IMPORTANT RECALL INFORMATION #50615 July, 2005

SUBJECT: RECALL CAMPAIGN #50615
2004 & 2005 Prowler, Wilderness and Terry
365 FLTS Fifth Wheel Trailer
Missing Chassis Cross-Member Welds

RECALL BULLETIN:
50615

Installation of
Steel Support
Tubes and an
Inspection and
Correction of
Chassis
Cross-Member
Welds

Figure 1

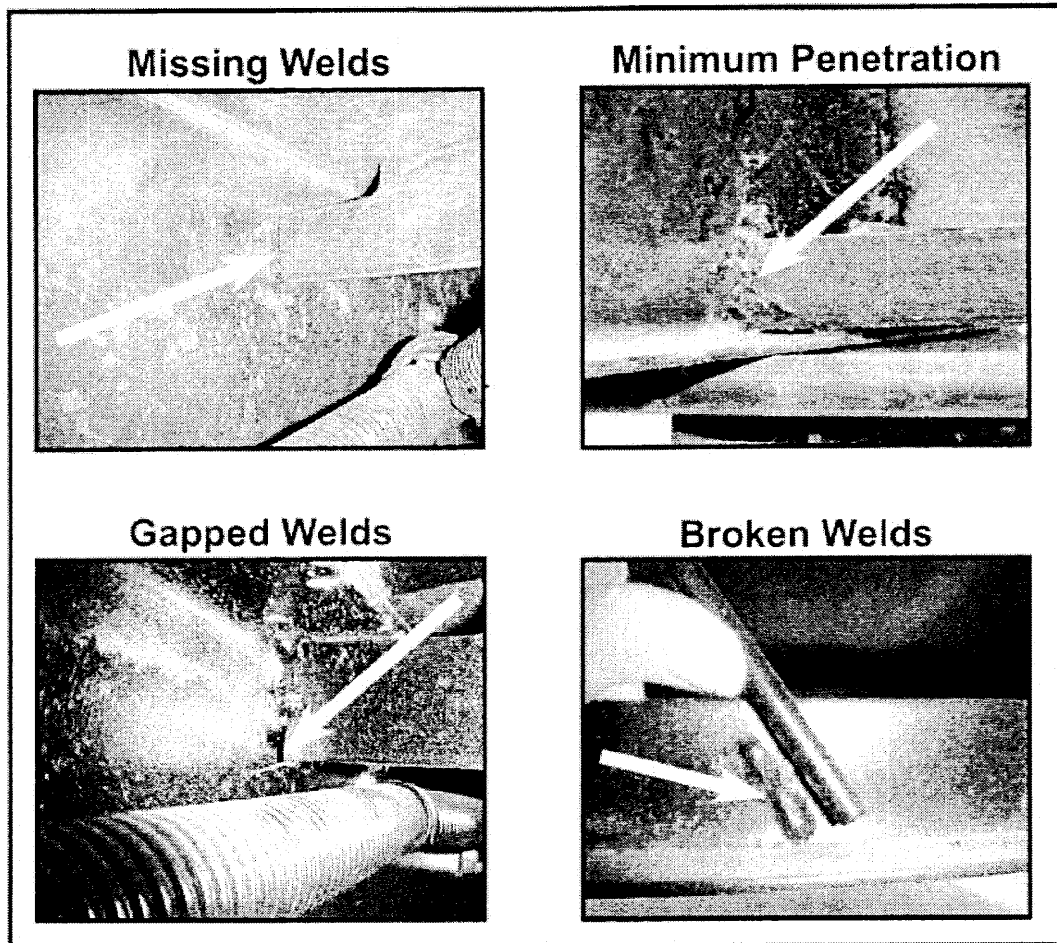
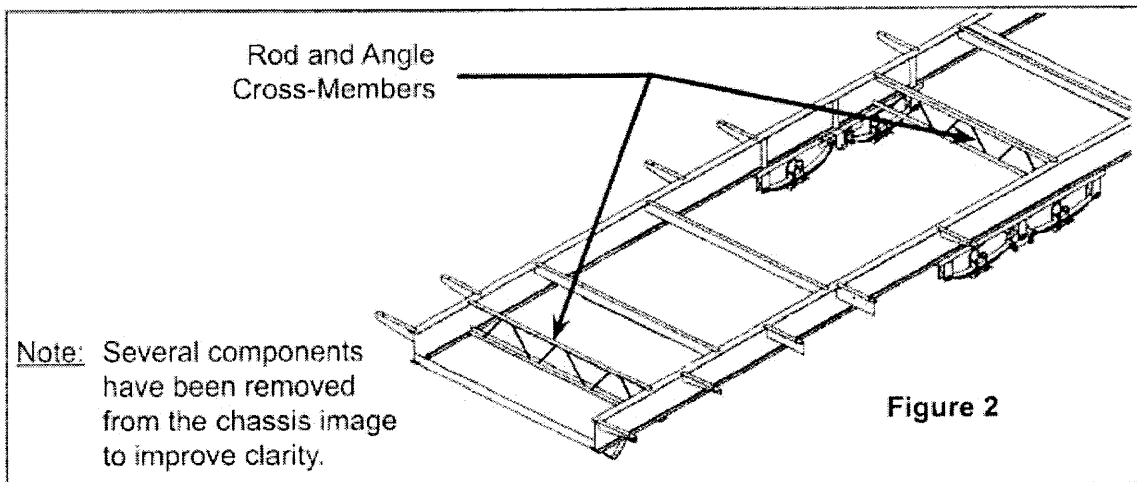
Follow the steps below to inspect the welds on the two (2) Rod and Angle chassis frame cross-members. If any of the welds are missing or improper, corrective action must be taken by following the Weld Repair Procedure section of the Bulletin. Use the photographs in Figure 1 for weld condition reference.

1. Inspect the vertical welds for the top and bottom angle iron attachments to the chassis frame rail, 8 locations.
2. Inspect the horizontal welds for the bottom angle iron attachments to the chassis frame rail, 4 locations.
3. Inspect all rod welds at the angle iron attachment points. Pull and push on the rods at each weld location to inspect weld condition. All loose, damaged, or missing welds will require correction. See Figure 1. Continue with the Weld Repair Procedure section of this Bulletin.

Examples of Welds that Require Correction

1. Grind out original welds on the Rod and Angle cross-member, identified as inadequate during the inspection process, before correcting.
2. For each weld, clamp the rod to the angle iron and correct all inadequate or missing welds on the Rod and Angle cross-member. Weld corrections must include the angle iron attachments to the chassis frame rail.

Figure 3

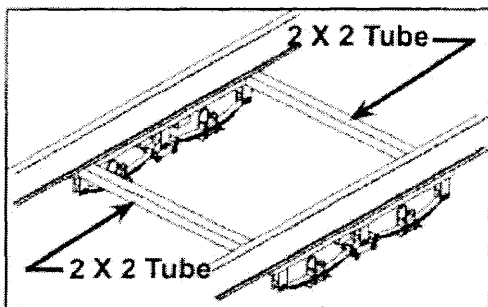
3. Measure the distance between the door-side and the road-side **FRONT** axle hanger mounting tube. See Figure 3-4.
4. Measure the distance between the door-side and the road-side **REAR** axle hanger mounting tube. See Figure 3-4.
5. Cut an 11 gauge 2" X 2" steel tube to each of these measurements. Mark the tubes for the front and rear locations.

6. Weld the complete perimeter of each end of the 11 gauge 2" X 2" steel tube to the front and rear axle hanger mounting tubes. See Figure 3-4.
7. Paint all bare metal and welds.
